Re: Draft Environmental Impact Report for the South Bay Substation Relocation Project, Chula Vista, California

The San Diego National Wildlife Refuge Complex (Complex) has reviewed the draft Environmental Impact Report (EIR) for the South Bay Substation Relocation Project located in Chula Vista, California. We offer the following comments for your consideration.

Figure 3:
Proposed Project/Bayfront Enhancement Alternative Simulation:
Proposed Air-Insulated Substation and Lattice Tower Removal
 (View from Bay Boulevard at Proposed Entrance Gate, Looking West)

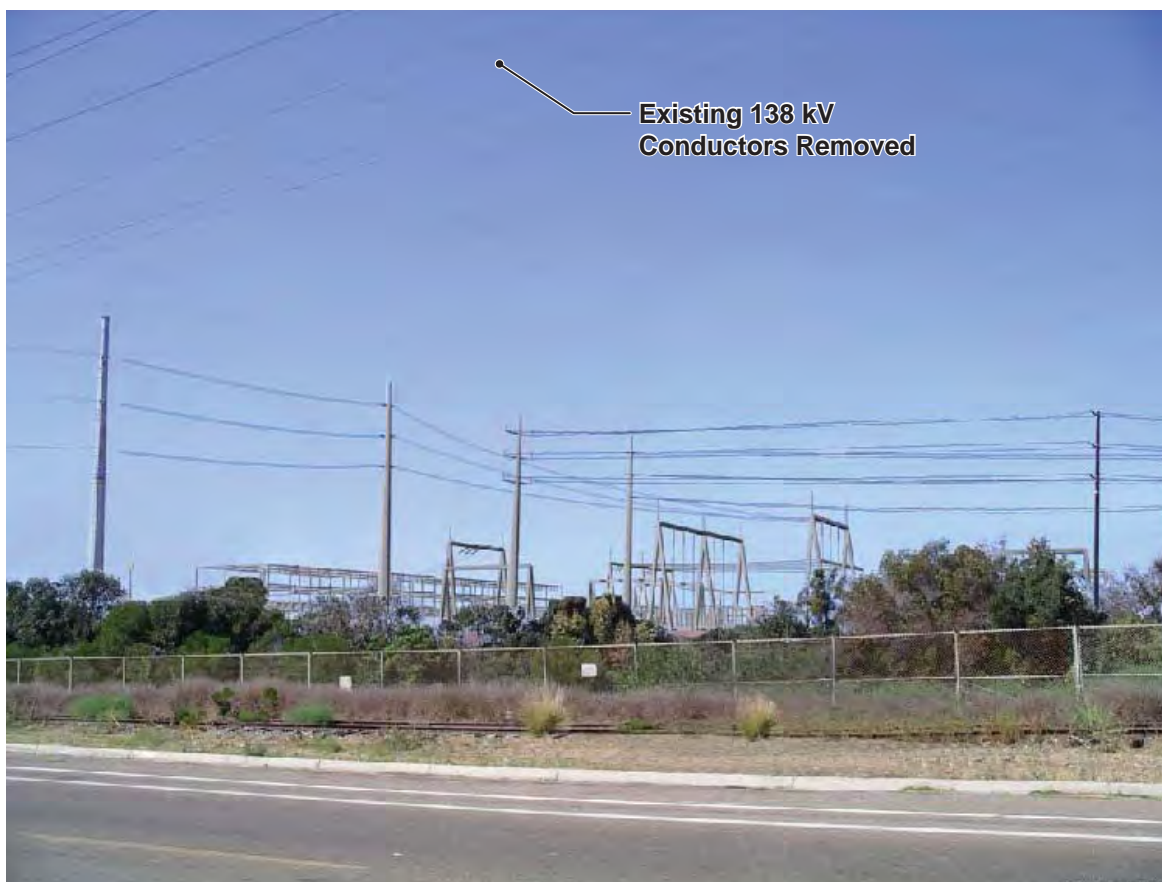
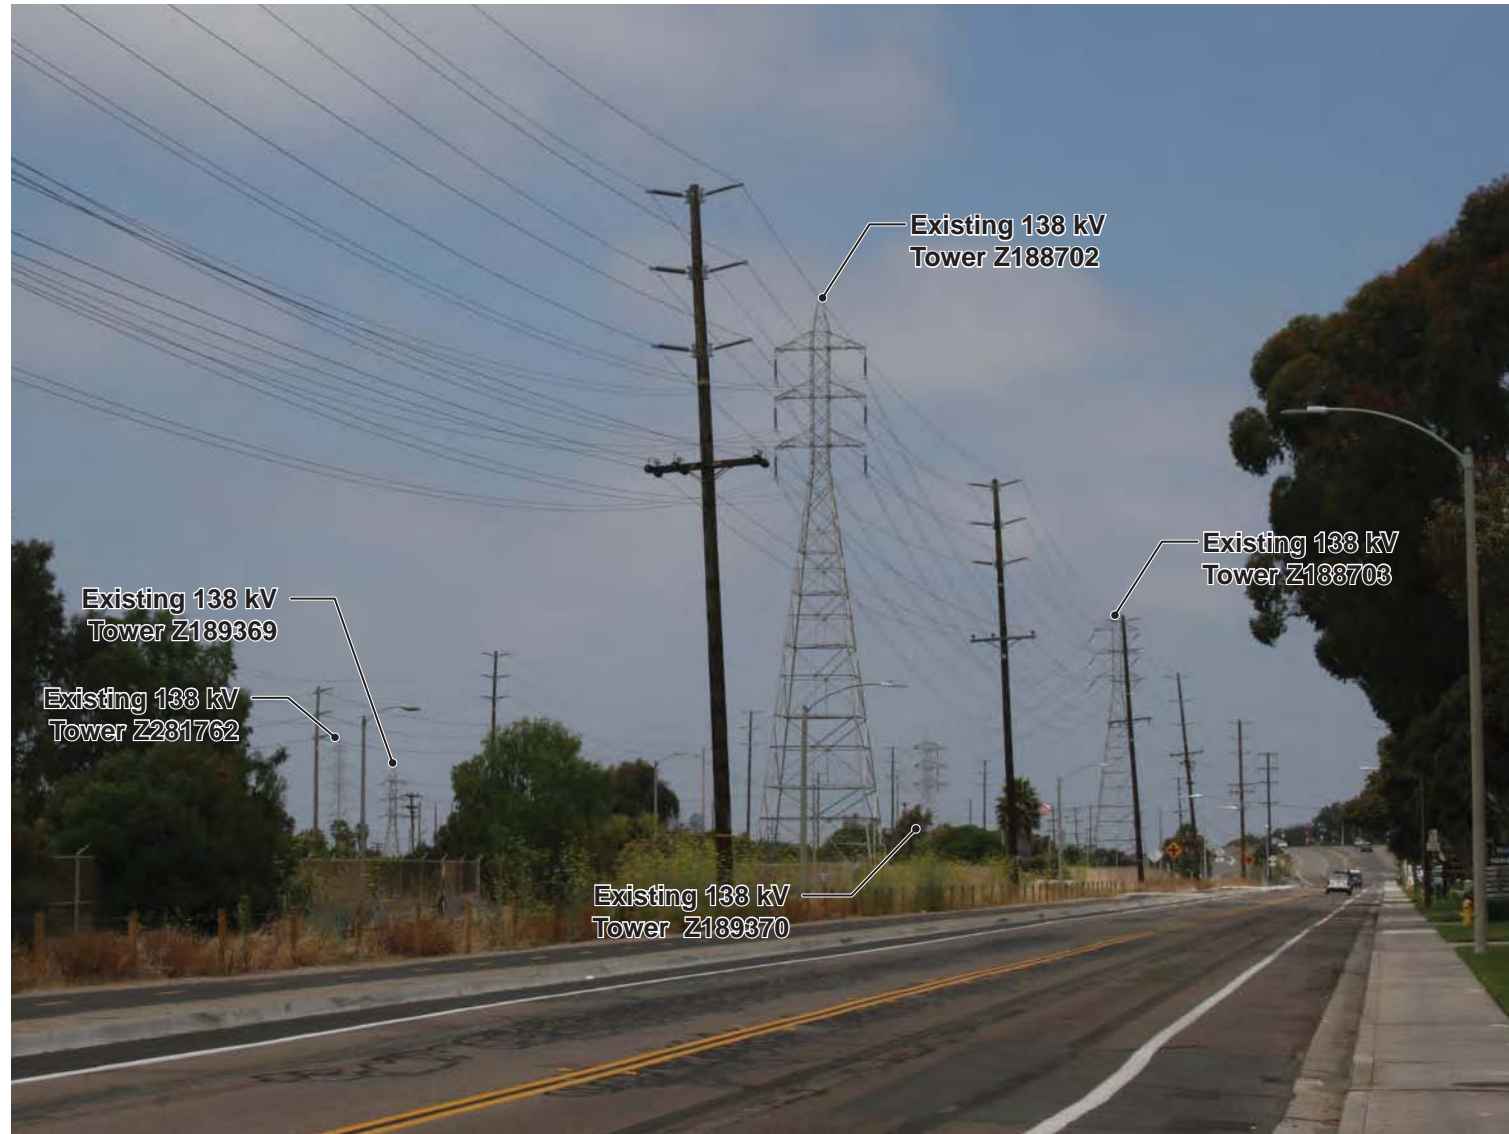
Figure 3: Proposed Project/Bayfront Enhancement Alternative Simulation: Proposed Air-Insulated Substation and Lattice Tower Removal (View from Bay Boulevard at Proposed Entrance Gate, Looking West) provides a depiction of the existing setting compared to a simulation of the Proposed Project and to the removal of Tower 1 (188701) that would result from implementation of the Bayfront Enhancement Alternative. Figure 4: Proposed Project/Bayfront Enhancement Alternative Simulation: Proposed Substation and Cable Pole Removal (View from Bay Boulevard North of Palomar Street, Looking Southwest) depicts the existing setting of the new Bay Boulevard Substation site compared to a simulation of the Proposed Project and to the removal of cable riser pole 24, which would be included as part of the Proposed Project, but eliminated by the Bayfront Enhancement Alternative design. As depicted, the removal of this tower and relocation of proposed cable riser pole 24 would result in a clearer view of the San Diego Bay than what currently exists or than that proposed for the Proposed Project.

Figure 8: Construction Vibration Amplitudes

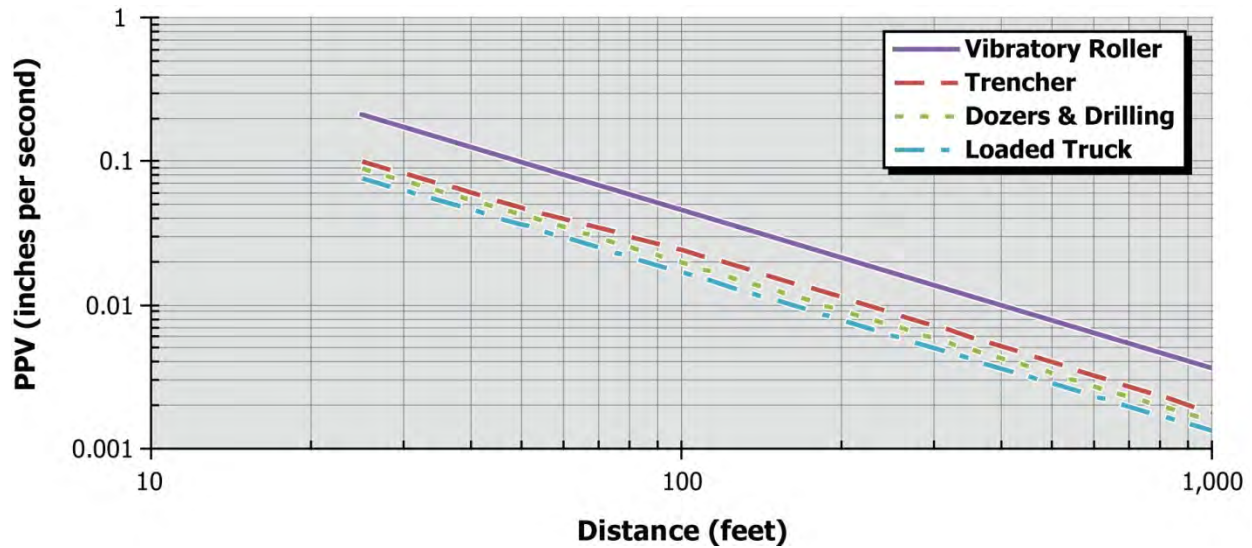
As depicted in Figure 8: Construction Vibration Amplitudes, at a distance of approximately 80 feet construction equipment would generate vibrations with an amplitude of less than 0.03 inch per second. This is below the potentially significant level of 0.032 inch per second. As a result, impacts from vibration would be less than significant.
